Subject: **NCDOT Response to Request for Additional Information Dated April 22, 2019, and subsequent Application Modification** for the Widening of US 70 from Mt. Hope Church Road to Sun Lake Road in Guilford County. NCDOT Division 7, TIP No. U-2581 BA, WBS 34840.1.4.

PERMIT DRAWING
SHEET 2 OF 14
Revised 5/30/2019

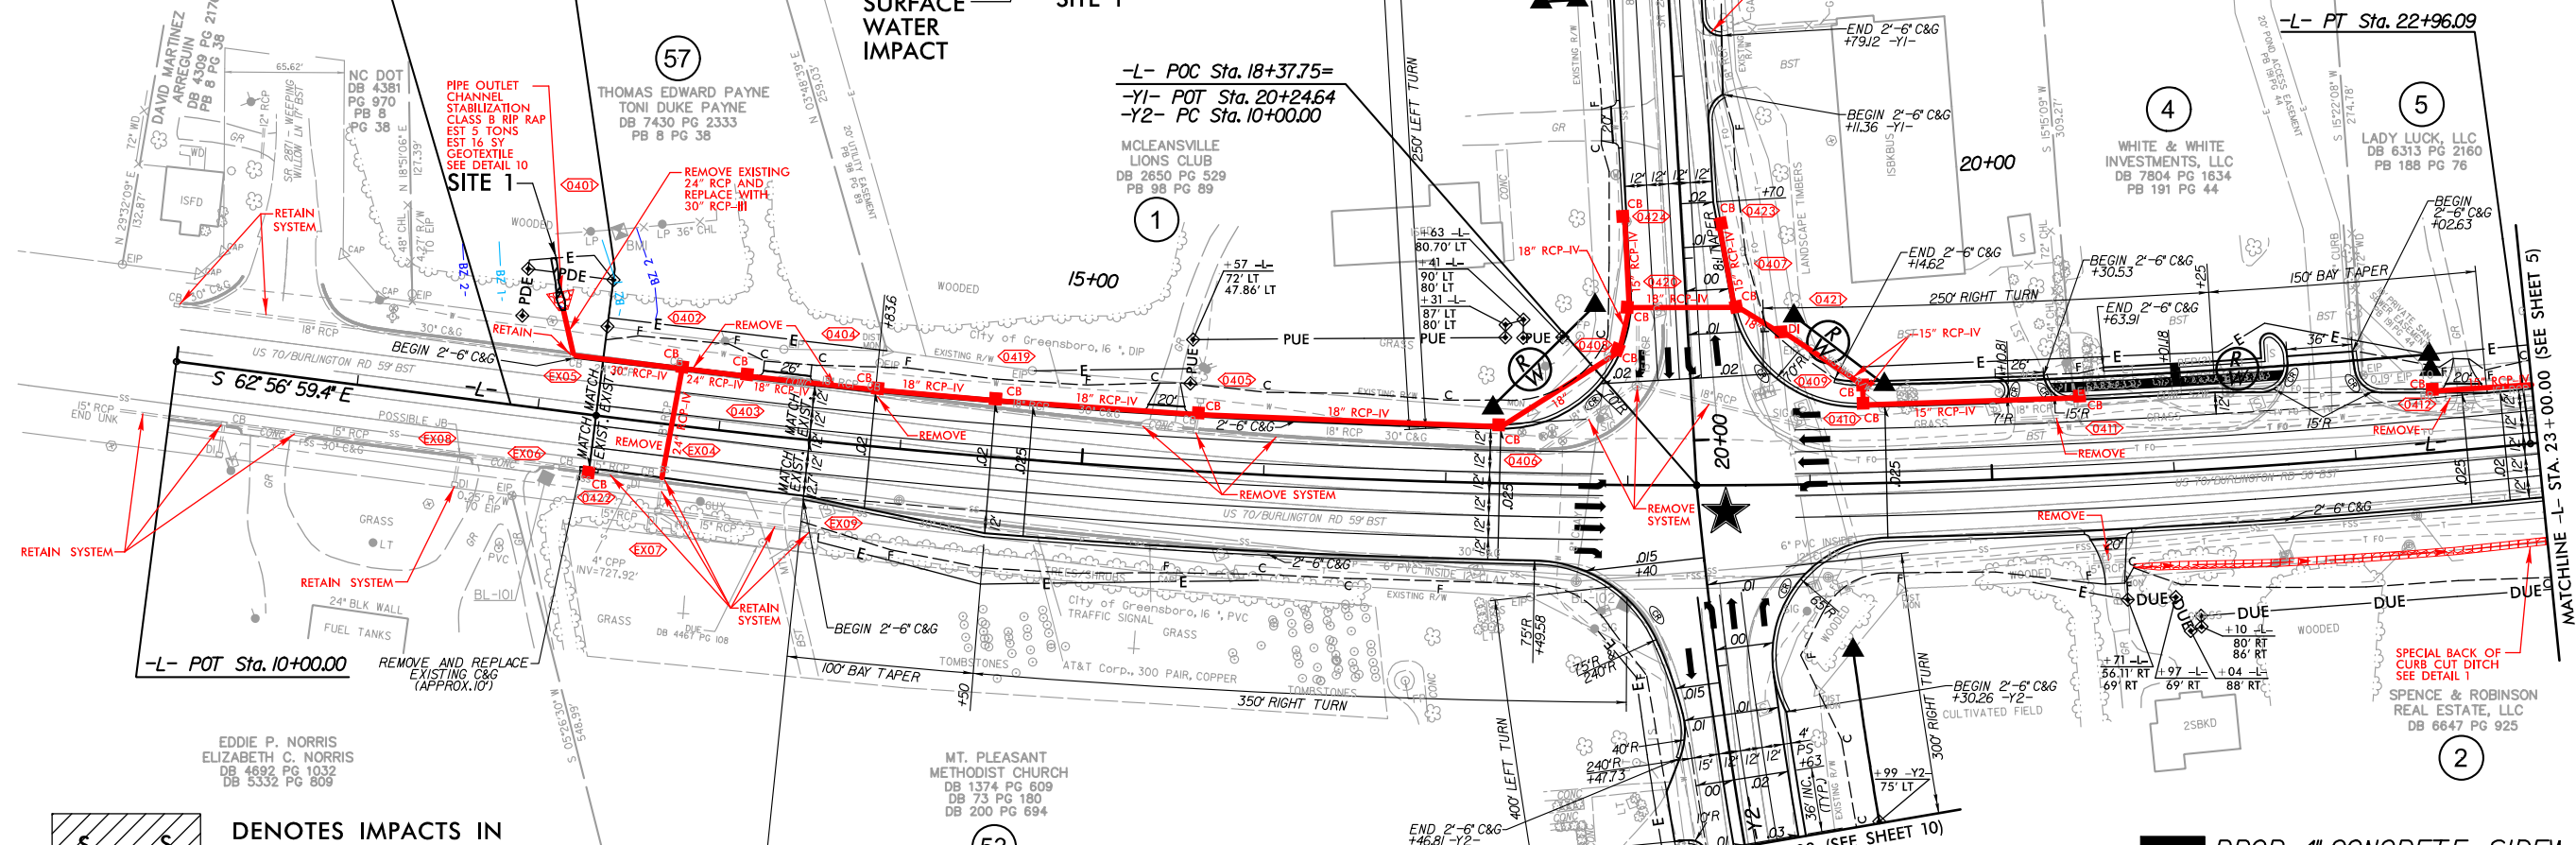
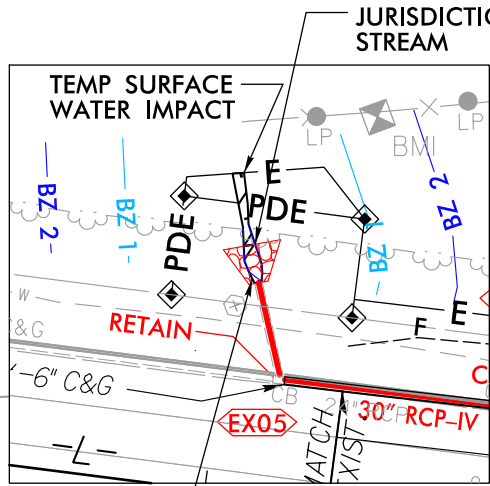
Site 1

Detail 10 was added to display the cross section of the stabilization impact at the pipe outlet. The rip-rap will be "keyed-in" to stabilize the system, but not impede aquatic passage.

BUFFER DRAWING
SHEET 2 OF 7
 Revised 5/30/2019

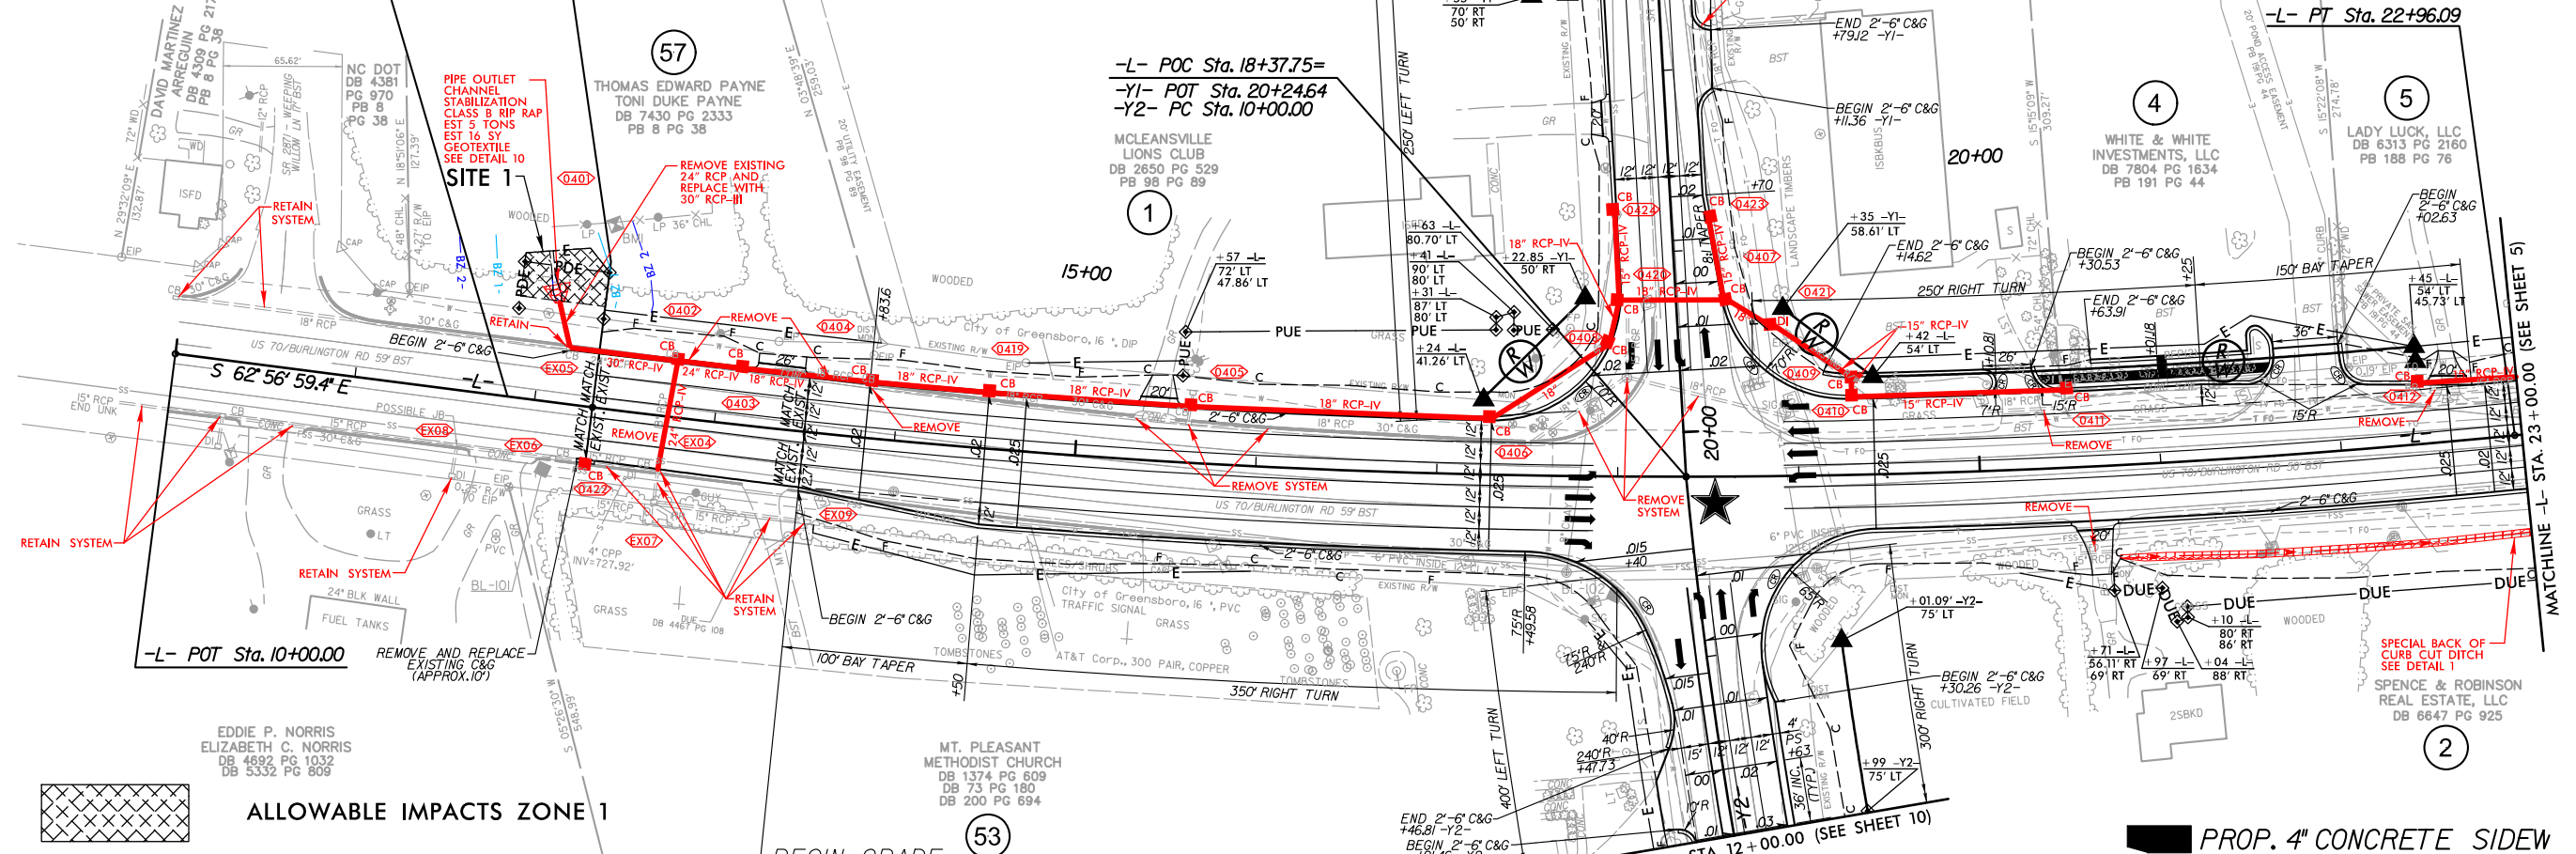
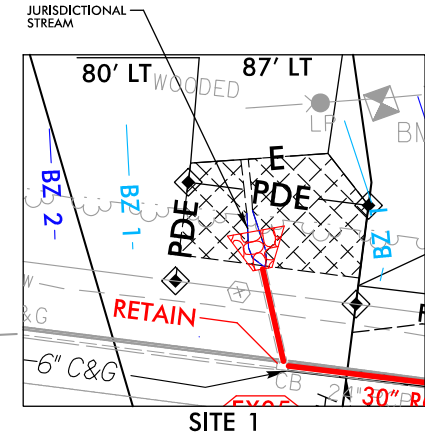
The buffer drawings have been revised to match the changes in the drawings. However, there are no changes to Buffer Impacts as a result of these revisions.
